SUBJECT: Valid Existing Rights--Price River Coal Company
and the Willow Creek Cemetary

Subject: Price River Coal Company, Price River
Complex, Carbon County, Utah, Mining
and Reclamation Plan (MRP)

Price River Coal Company
Price River Mine Complex
Application for Mining and Reclamation Plan

DRILL HOLE MC-52

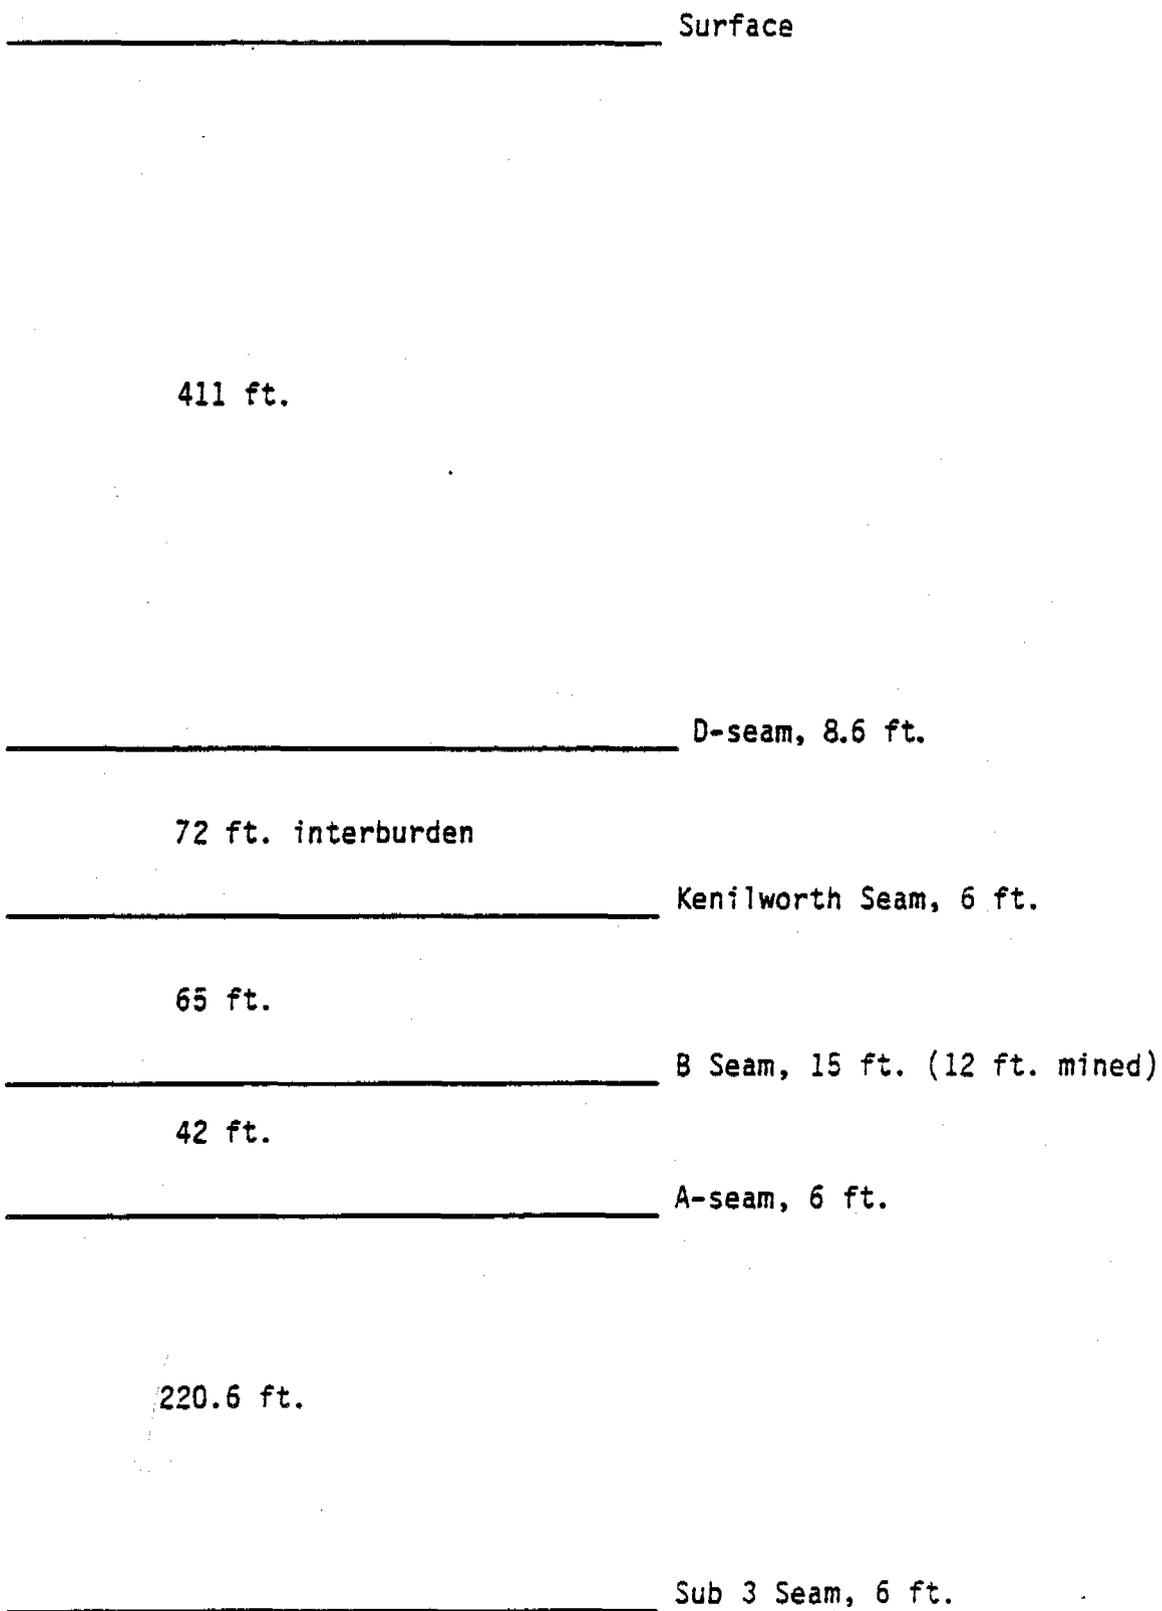
Although this hole was not drilled through the Aberdeen to the Sub 3 Seam, the occurrence of the Aberdeen is very consistent throughout this area. Detailed lithologic information was submitted for three other drill holes and in each of these holes, the Aberdeen sandstone existed.
